**RE: REVISIONS TO COMPOSITE CAP
BENTON COUNTY SANITARY LANDFILL
IDNR PERMIT NO. 06-SDP-02-81P
HLW PN 6043-23A.200**

FINAL COVER DETAIL SUBTITLE D COMPOSITE CAP

FIGURE: 1

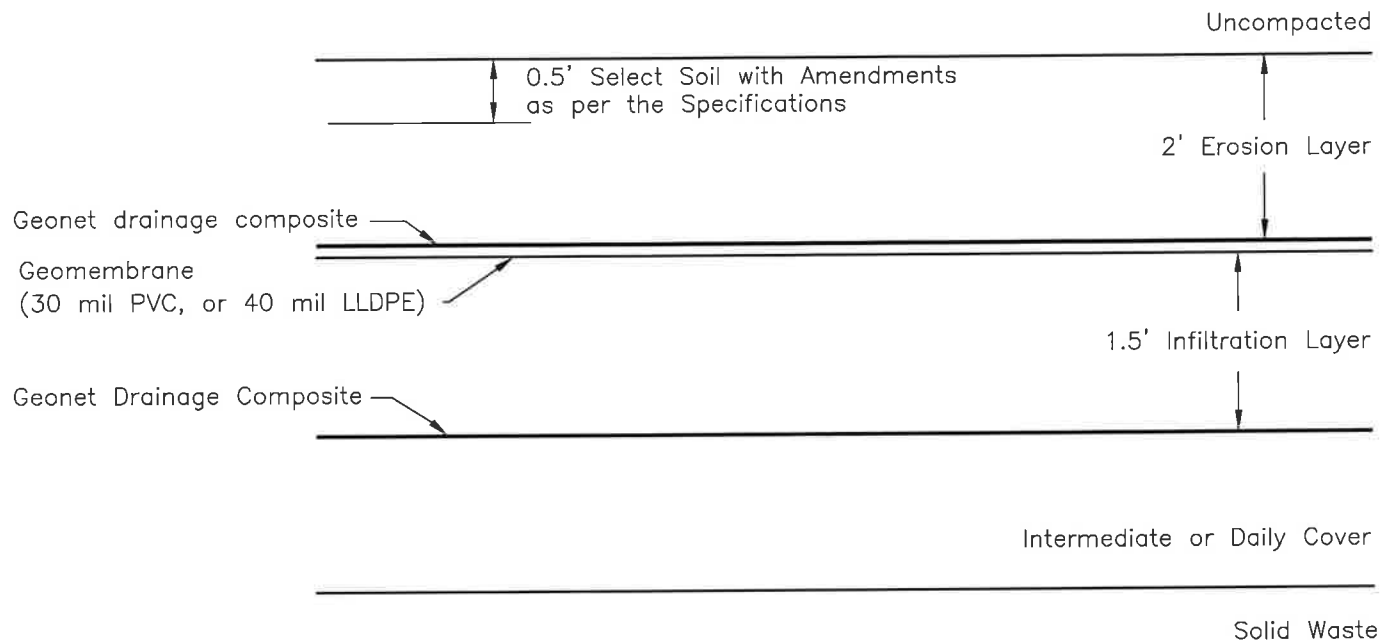
Attached for the review and approval of the IDNR is a detail to document proposed changes to the Subtitle D composite landfill cap at the Benton County Sanitary Landfill. The Closure/Postclosure Plan and design details such as cap stability, drainage net hydraulic calculations, and other pertinent design information will be addressed at the time of the next SDP Permit renewal or prior to the next cap construction.

- The Engineer shall determine the suitability of soil for use in the infiltration layer based on the results of lab hydraulic conductivity tests.
- The lower geonet composite will serve as the gas control layer.
- The select soil shall be from the best available soil for vegetative growth from borrow areas or stockpiles. Soil amendments shall be applied as per the specifications. The layer should be disked and prepared for seeding and mulching as required in the specifications.
- The upper geonet drainage composite will outlet into drainage piping on the slope and at the toe of the slope.
